# Easton Staff Development Review MEETING AGENDA

**Project Name:** Somerset Well Drilling

**FROM:** Joseph A. Mayer - Plan Reviewer, Planning & Zoning Department  
**SUBJECT:** 28580 Mary's Court, Lots 16 & 20

We reviewed the **January 2, 2025** Sketch Plan Submittal for the Subject Project and have the following comments:

### Link 56L: POI 3 (EX SWM POND)

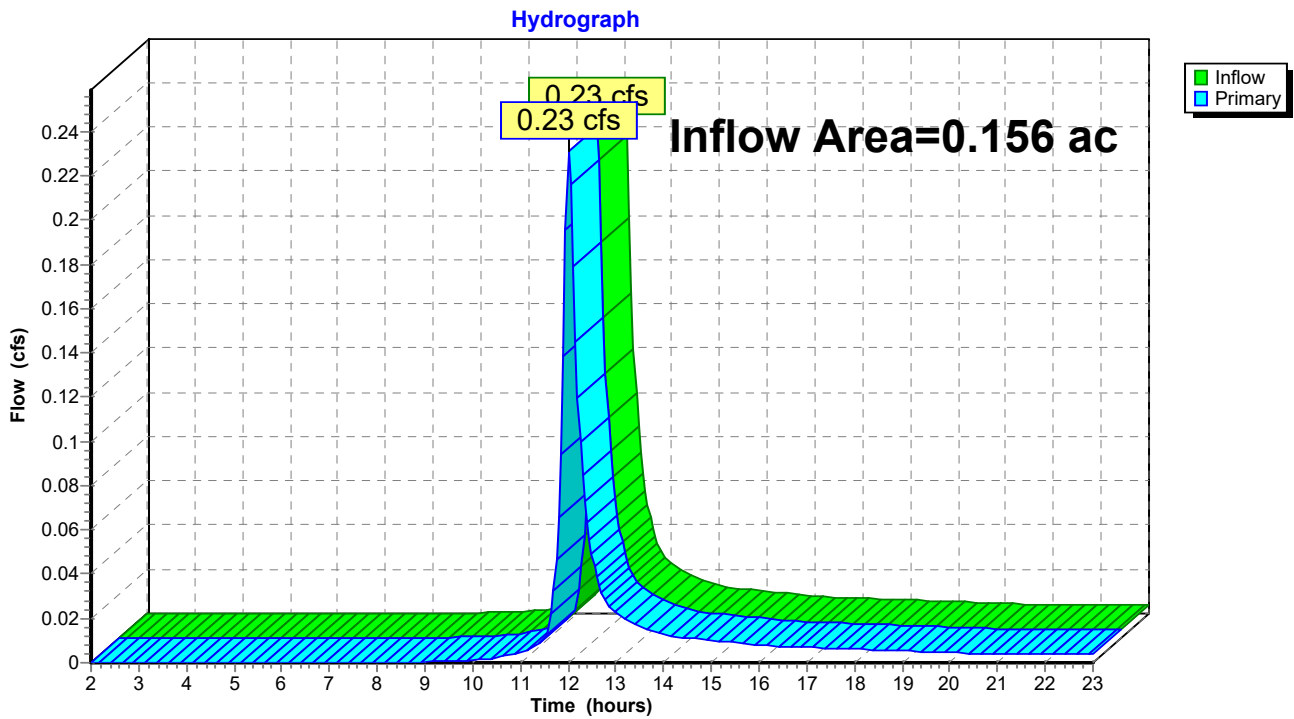
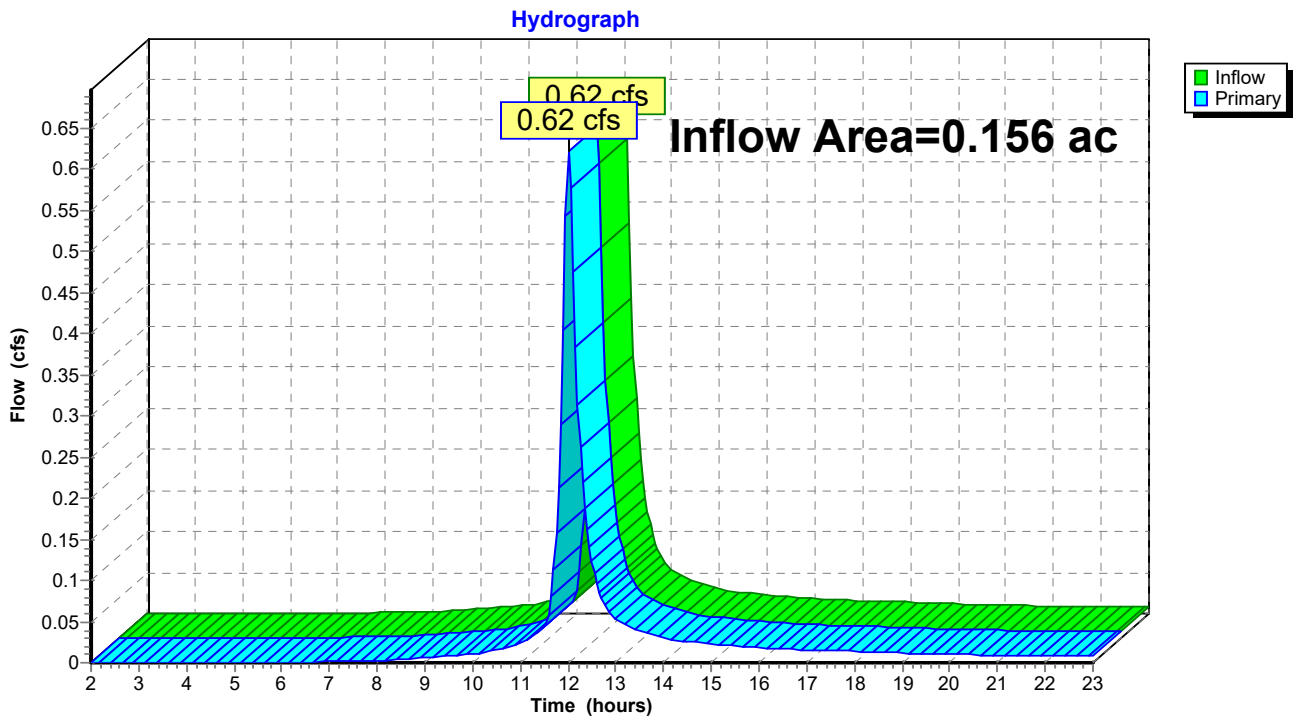
1. POI#3 indicates an increase in runoff . Please revise.
2. Provide Critical Area 10% Rule Calculations in the form of the State Spreadsheet for each of the 3 Drainage Areas. The RR Required and Provided should be added to the ESD SUMMARY CHART on Sheet 2 of 2.

*The proposed grading has been modified to reduce the overall drainage area to POI #3, resulting in a decrease in post-development runoff for all storm events.*
